Access Compliance Report Public Rights-of-Way (Curb Ramps)

Main Street: CHIQUITA_CANYON_DR Cross Street: AIROSO_ST Location: S

ADA ID: RPRK211124131623 Ramp Type: Type 1 - Perpendicular Initial Pass/Fail: Fail Overall Compliance: No Severity Score: 2

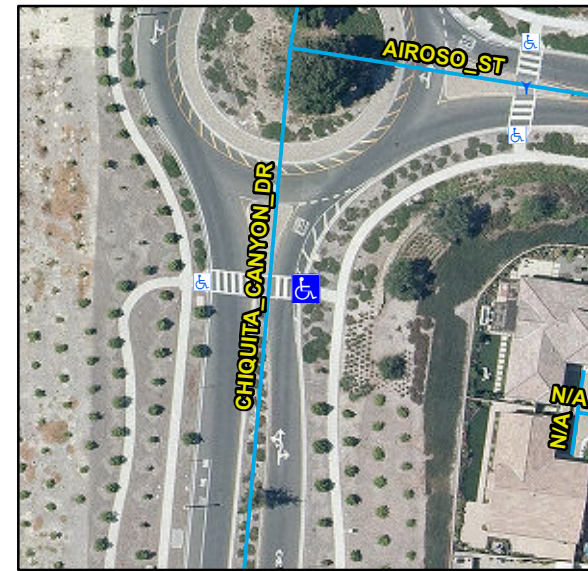
Compliance	Description	Data	Compliance	Description	Data
N/A	Ramp Length (in)	62	N/A	Flare Type LT	
Yes	Ramp Width (in)	60			N/A
Yes	Ramp Run Slope (%)	2.8	N/A	Flare Slope LT (%)	N/A
No	Ramp Cross Slope (%)	3.6	N/A	Flare Traversable LT	N/A
N/A	Landing Present	N/A	N/A	Flare Type RT	
N/A	Landing Length (in)	N/A			N/A
N/A	Landing Width (in)	N/A	N/A	Flare Slope RT (%)	N/A
N/A	Landing Run Slope (%)	N/A	N/A	Flare Traversable RT	N/A
N/A	Landing Cross Slope (%)	N/A	N/A	DWS Provided	N/A
N/A	Landing Movement Obstructed?	N/A	N/A	DWS Contrast	N/A
	Landing Movement Type	N/A	N/A	DWS Length (in)	N/A
N/A	Landing Shared	N/A	N/A	DWS Full Width	N/A
N/A	Clear Space	N/A	N/A	DWS Offset Left (in)	N/A
N/A	Clear Space To Crosswalk (in)	N/A	N/A	DWS Offset Right (in)	N/A
N/A	Marked Crosswalk 1	Yes	N/A	Marked Crosswalk 2	N/A
	Crossing 1 Direction	W		Crossing 2 Direction	N/A
	Marked Crosswalk 1 Width (in)	144		Marked Crosswalk 2 Width (in)	N/A

N/A	Ramp Inside Crosswalk 1	Yes	Yes	Ramp Inside Crosswalk 2	N/A
	Crossing 1 Slope (%)	3.5		Crossing 2 Slope (%)	N/A
	Crossing 1 Cross Slope (%)	3.6		Crossing 2 Cross Slope (%)	N/A
N/A	Gutter Ponding	N/A	No	Curb Slope	7.5
Yes	Gutter Lip Height (in)	0		Road Run Slope (%)	N/A
N/A	Gutter Run Slope (%)	N/A		Road Cross Slope (%)	N/A
N/A	Gutter Cross Slope (%)	N/A			
Yes	Overall Surface Condition: Acceptable		Yes	Perp Joint Present	Yes
	Cross Gutter Present?	No		Spandrel Present?	No
	Replace Cross Gutter?	N/A		Replace Spandrel?	N/A

Possible Solutions:

Remove & Replace Entire Ramp.
